# CITY PLAN COMMISSION STAFF REPORT

**Prospect Summit Homes**

CD-CPC-2021-00014  
Rezoning with a plan

Report Date: April 28, 2021  
Case Number: CD-CPC-2021-00014  
Project: Prospect Summit Homes

Name on Seal  
 Robert C Harner  
 License No.: A5514  
 T&B #2015037508  
 DWG NO.:  
 C004

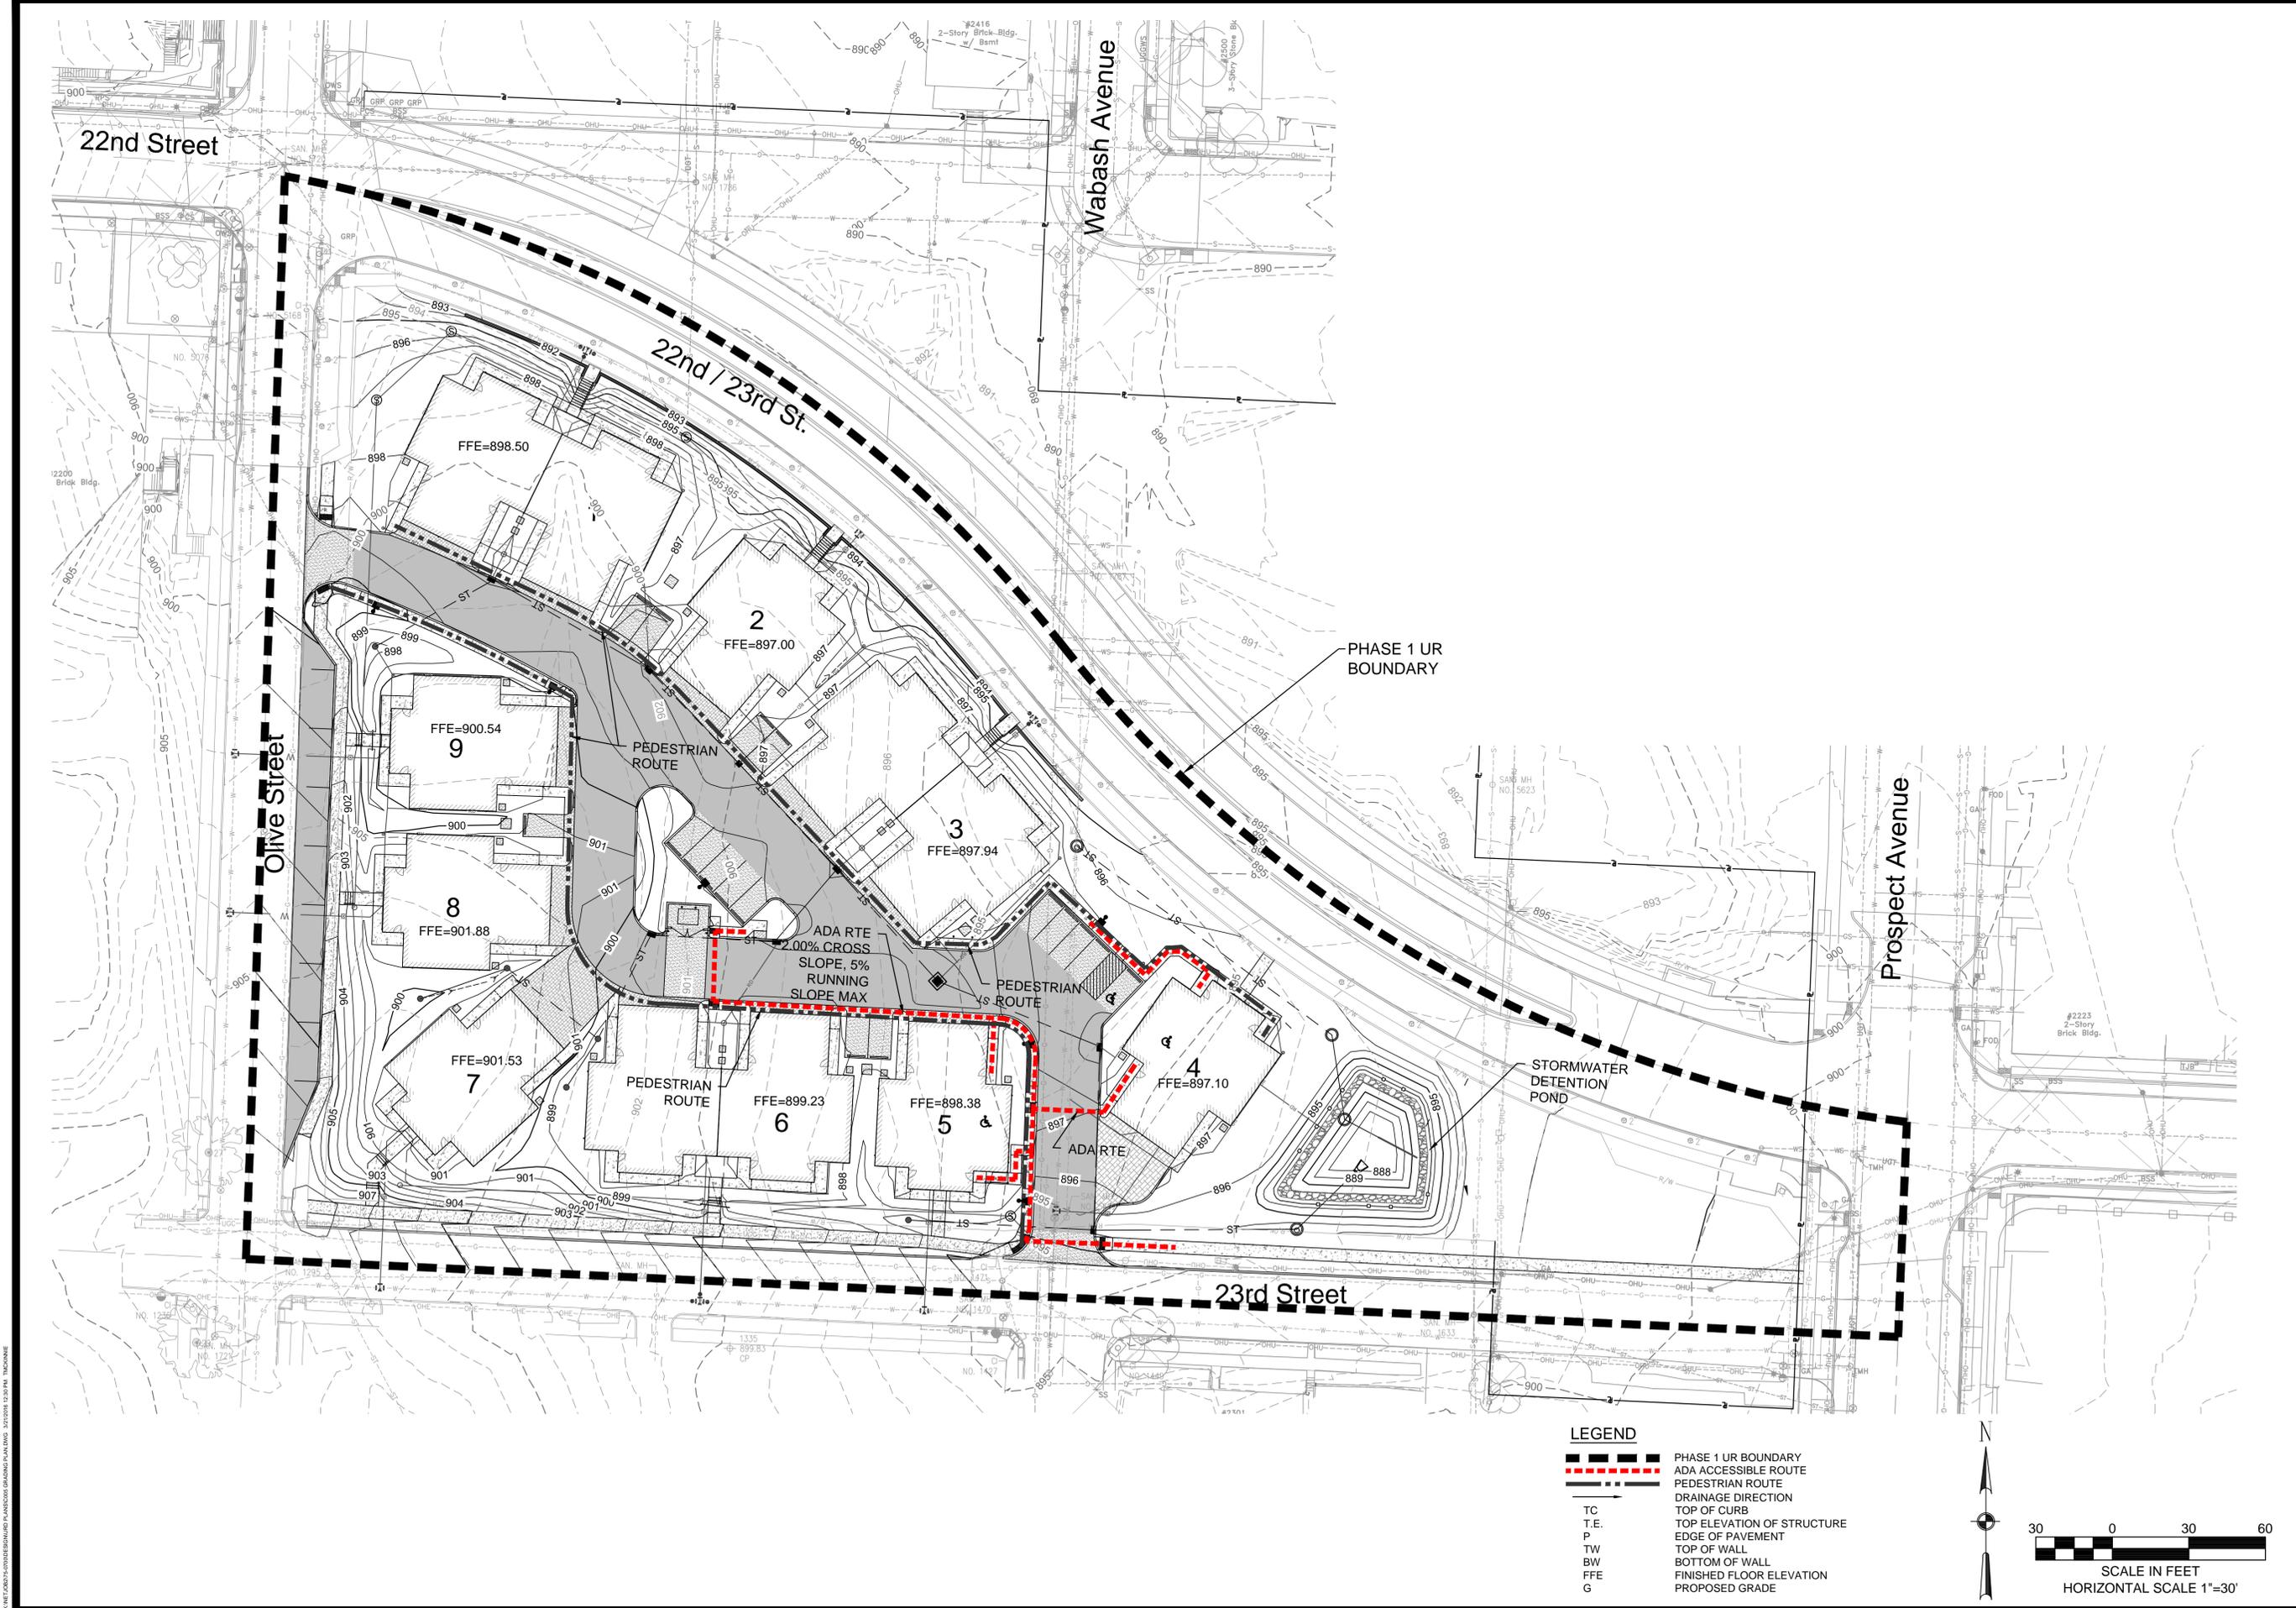
The standards of this section apply because this is a project plan. Staff recommends that the plans be revised so that sidewalks in the rear of the buildings within the parking o provide pedestrian accessibility. Convert #4

on sheet C004 to a sidewalk along the driveway for pedestrian use. This can be differentiated with different texture, material or paint to discourage vehicular parking.

3. Revise sidewalks in the rear of the buildings within the parking lot to provide pedestrian accessibility. Convert #4 on sheet C004 to a sidewalk along the driveway for pedestrian use. This can be differentiated with different texture, material or paint to discourage vehicular parking. Revise Plans and Resubmit (4/22/2021)
